Cylinder Head Change

**Mercury Pro-Max (ALL)
Mariner Super Magnum (ALL)
Mercury and Mariner MHP 2.5
Carb/EFI/EFI Offshore(Running
change)**

Figure 1. New Cylinder Head

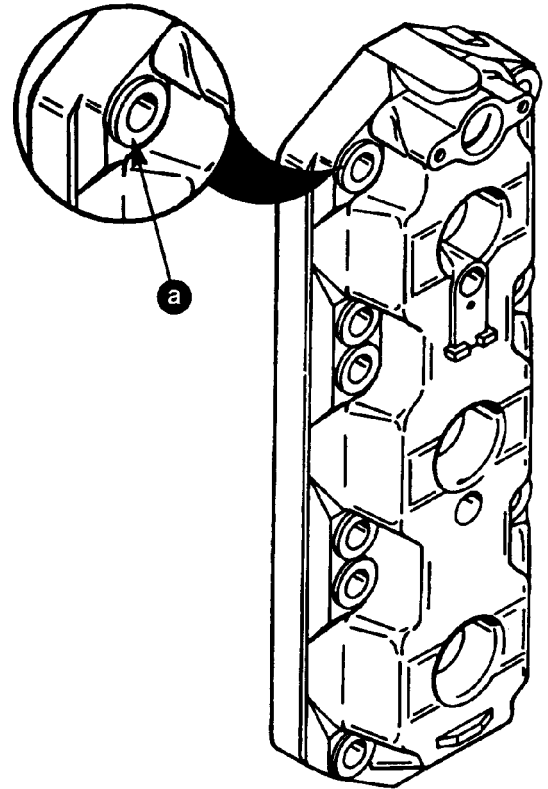
An improved cylinder head which has cast-in head bolt washers is used on the models listed. The cast-in washer eliminates the use of flat washers under the head bolt, (except MHP 2.5 engines). The torque sequence and the bolt torque are also cast into the cylinder head. The cylinder head attaching bolt p/n 10-98534 remains the same.

IMPORTANT: The heavy washer will continue to be used on all Hi-Performance 2.5 engines with the new cylinder head.

a - Cast-in material to eliminate washers

1. **Pro Max and Super Magnum:** DO NOT install a washer under the head of the bolt when the washer is cast-in the cylinder head.
2. **2.5 Carb/EFI and EFI Offshore:** Will continue to use the heavy washer on the head bolt with the new cylinder head.

Figure 2. Cylinder Head Bolt

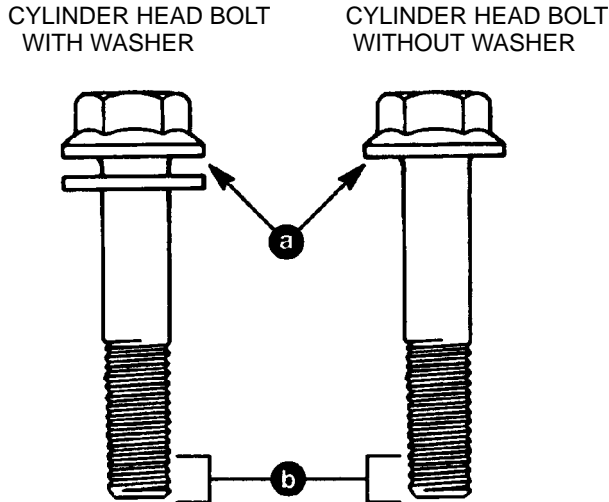
When replacing or installing a cylinder head bolt, apply 10W-30 or 2 cycle oil to the bolt head in the areas shown. The absence of lubrication may result in insufficient clamp load and possible head gasket failure.

- a - Oil under the washer or the bolt head
- b - Oil the first 4 threads

Figure 3. Cylinder Head Torque and Torque Sequence

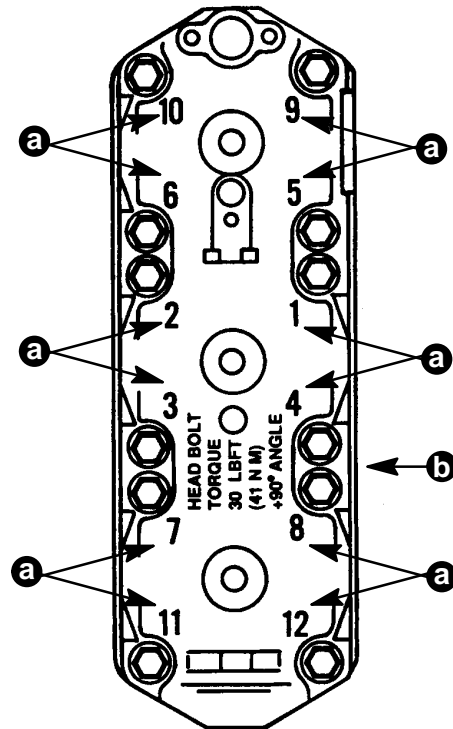
The cylinder head bolt torque has been changed on all models that have the new style cylinder head. Retorque of the new head bolts has been eliminated when using this new specification. The new torque specification is 30 Ft. Lbs.(41 N.m) plus an additional 90° / 1/4 turn.

- a - Cast-in Torque sequence
- b - Cast-in Head bolt torque

1st – Torque all bolts to: 10 Ft. Lbs (14 N.m).

2nd – Torque all bolts to: 30 Ft. Lbs (41 N.m).

3rd – Turn all bolts an additional 90° / 1/4 turn.

IMPORTANT: DO NOT retorque the head bolts when using this new specification. The clamping force can not be improved by retorqueing and the life of the bolt will be shortened.
